PARKERS RIDGE

STORMWATER MANAGEMENT CALCULATIONS

2nd Submittal: 6/1/2023

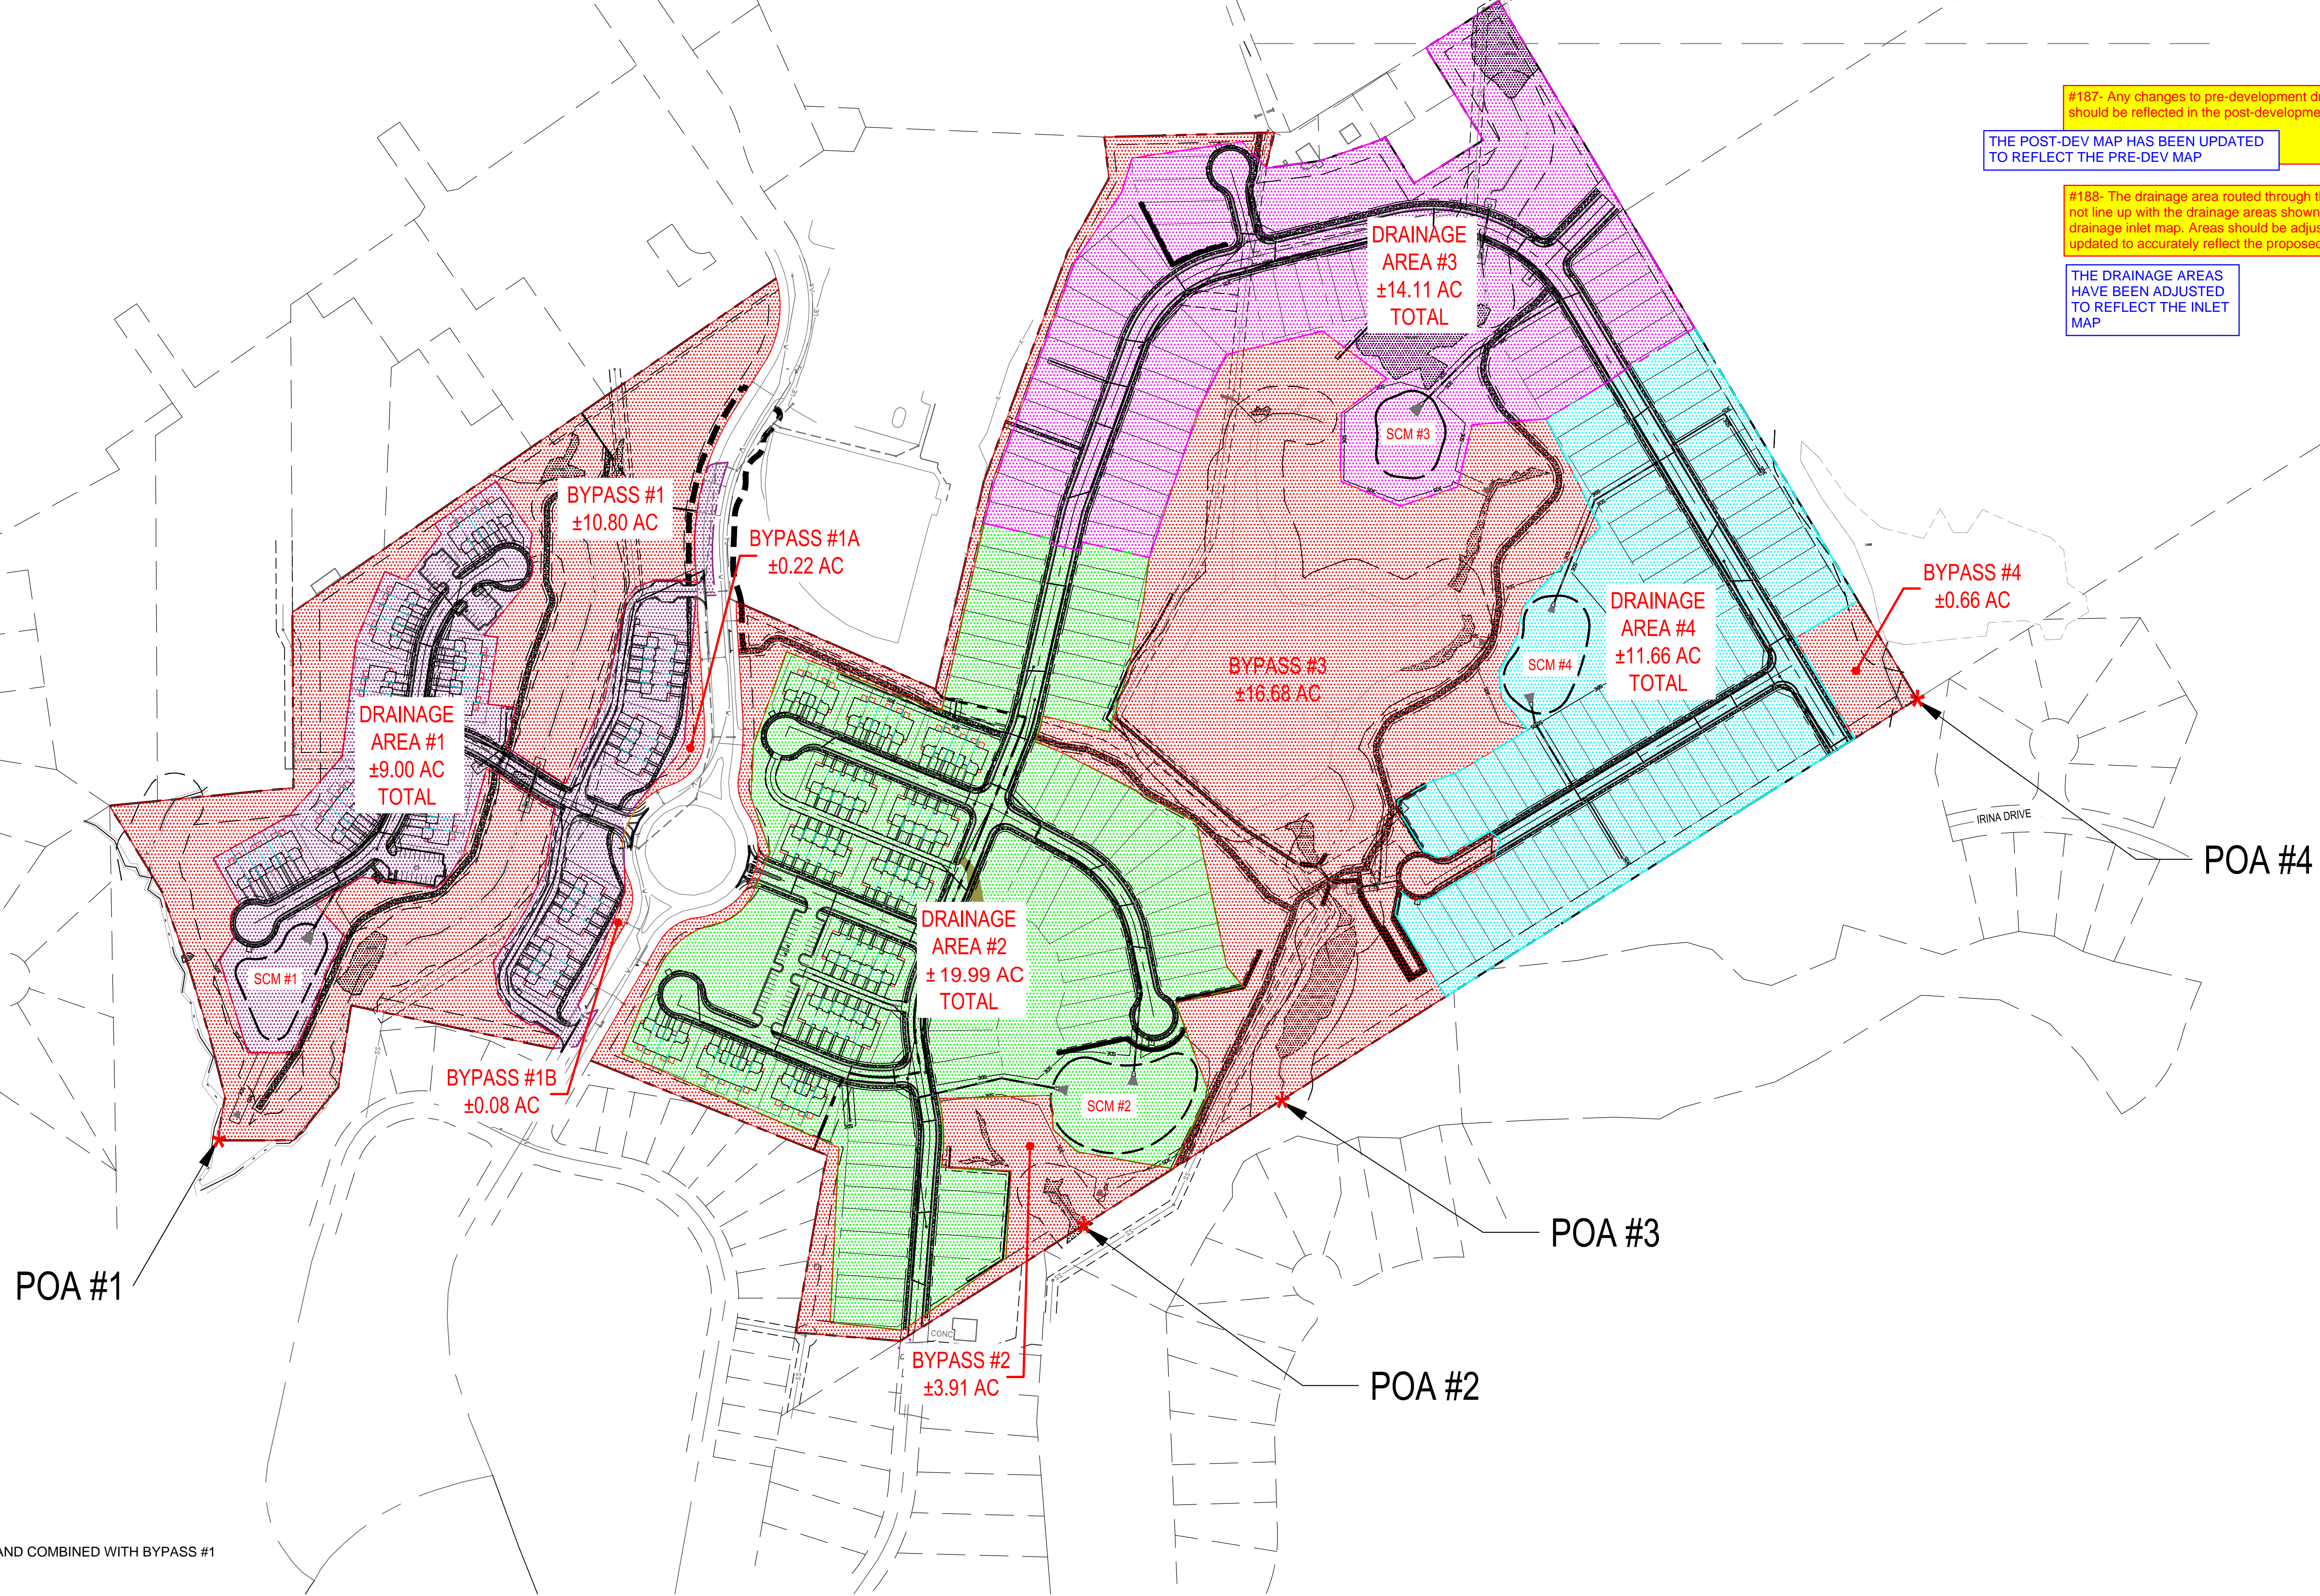
#187- This section is
not draining towards
POA #2
NEW POA HAS BEEN
ADDED

#187- What
elevations are these
contours at? Should
this be a different
drainage area?
NEW POA HAS BEEN
ADDED

#187- Any changes to pre-development drainage areas should be reflected in the post-development map.

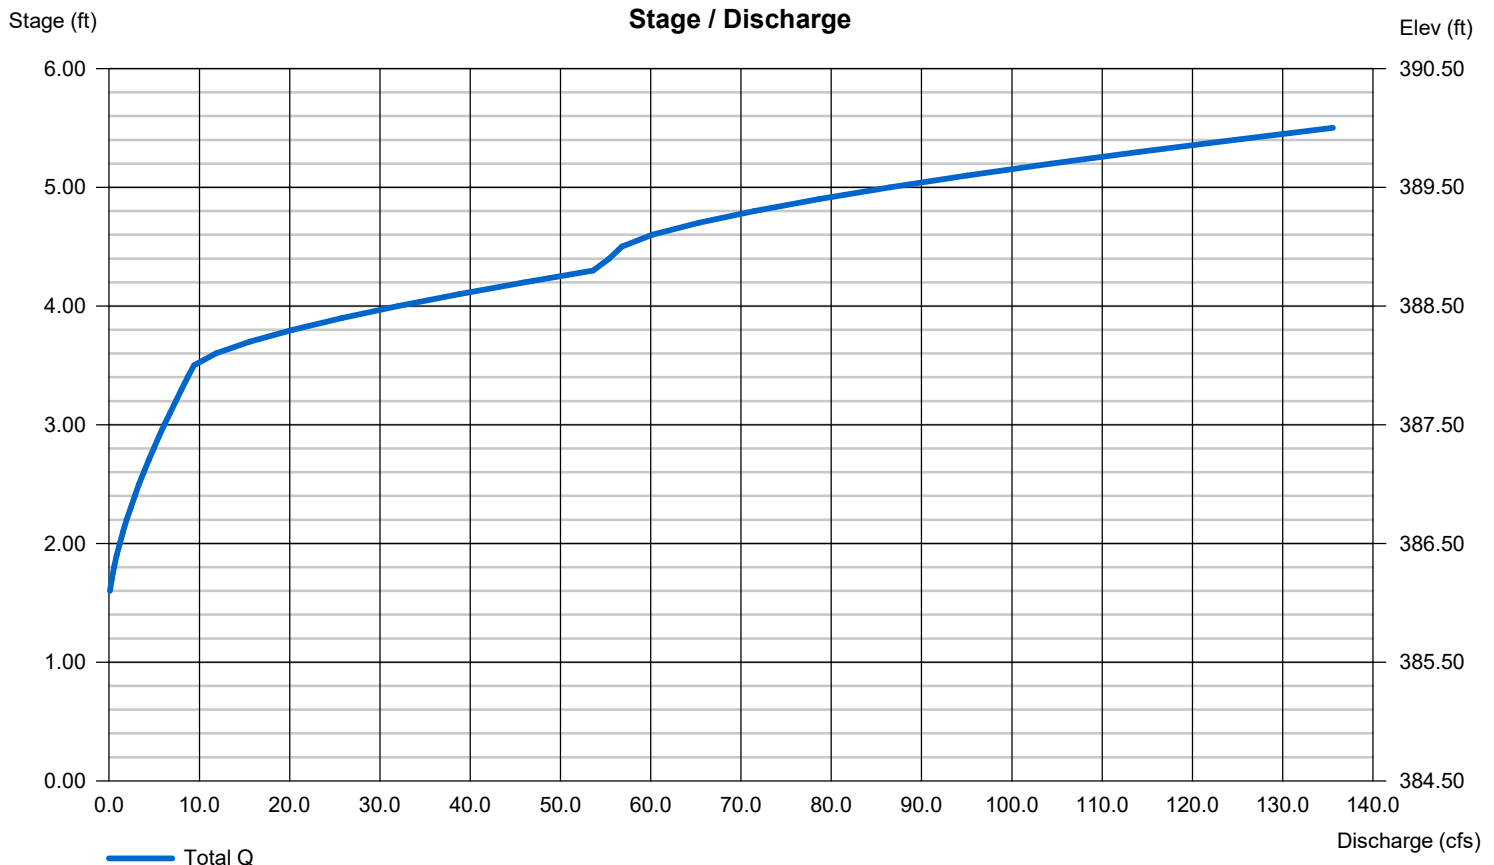
#196- verify this matches what is shown on the detail sheet

THIS HAS BEEN VERIFIED

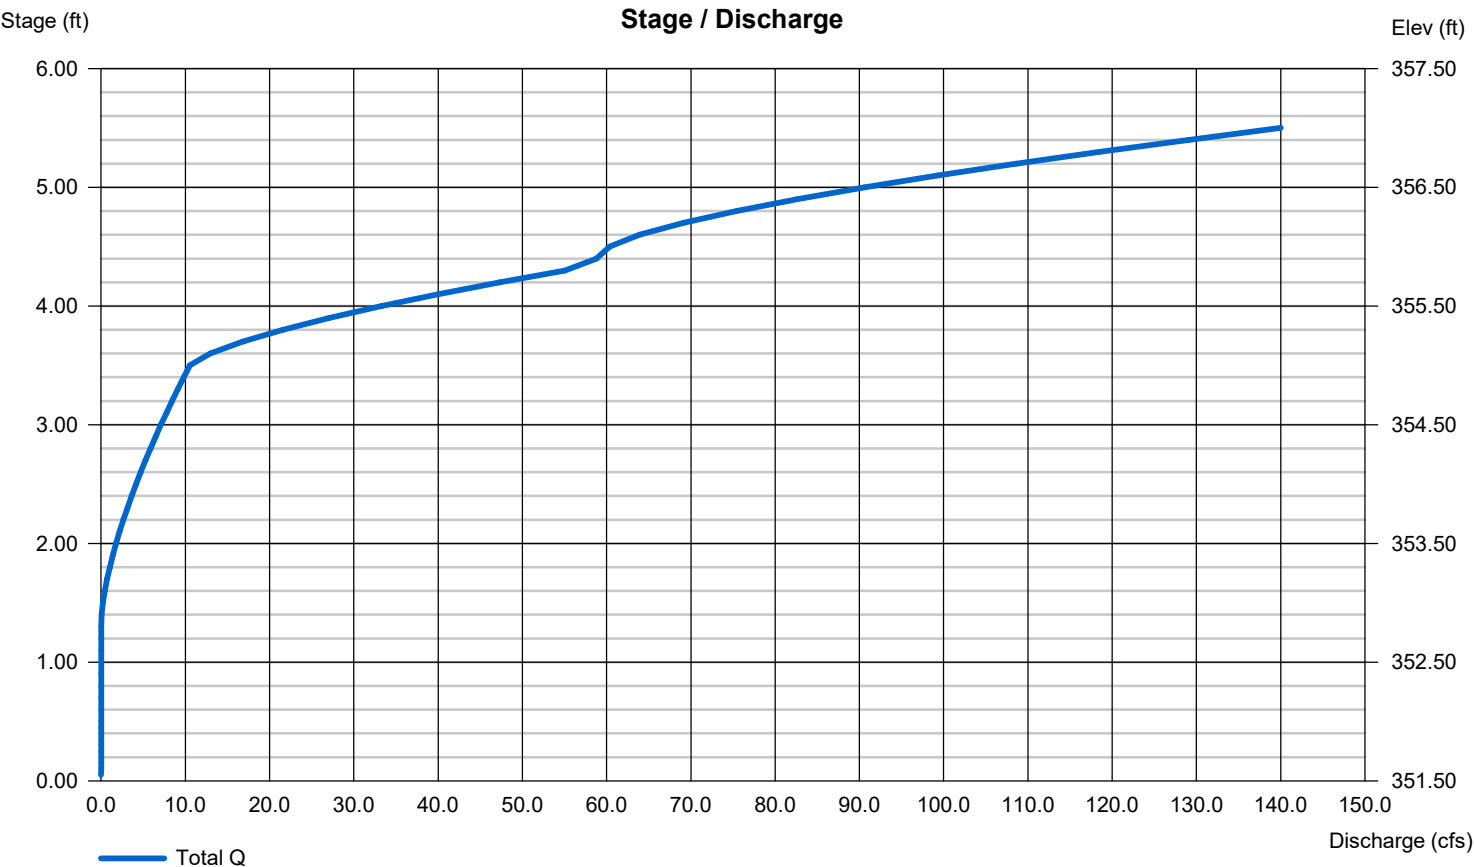
#196- verify this matches what is shown on the detail sheet

THIS HAS BEEN VERIFIED

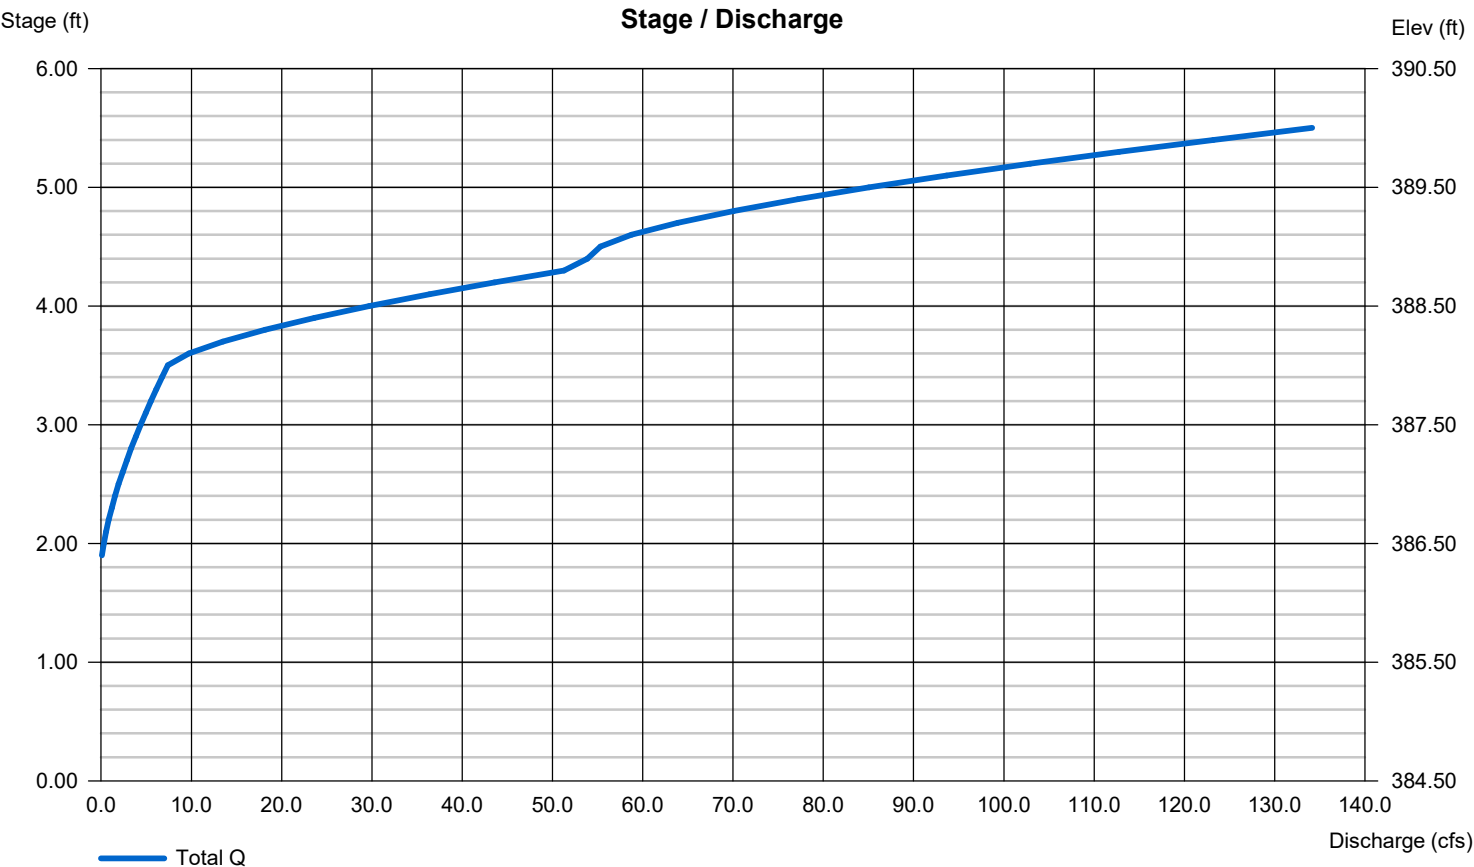
#196- verify this matches what is shown on the detail sheet

THIS HAS BEEN VERIFIED

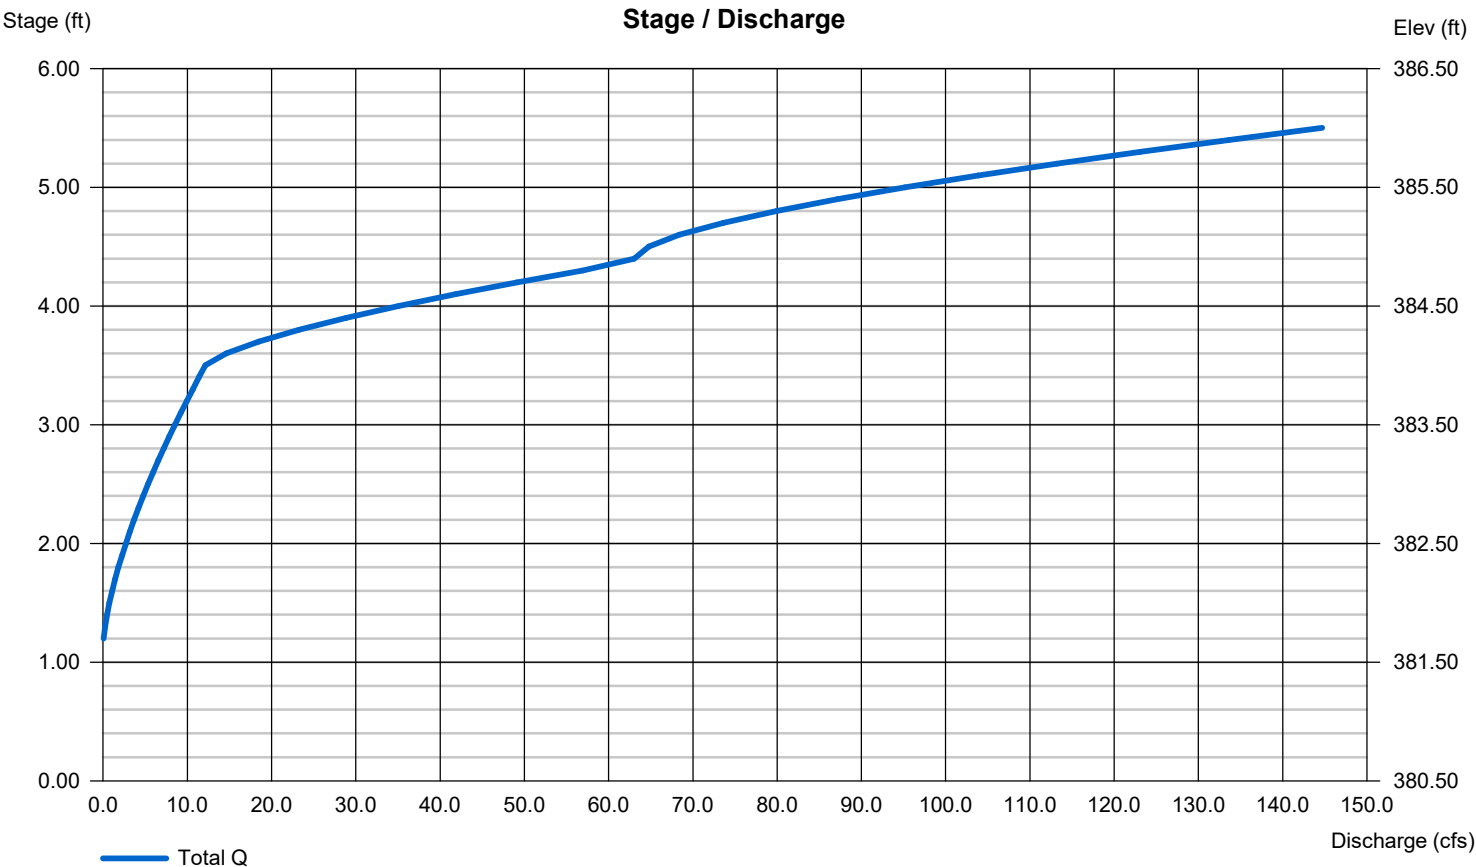
#196- verify this matches what is shown on the detail sheet

THIS HAS BEEN VERIFIED
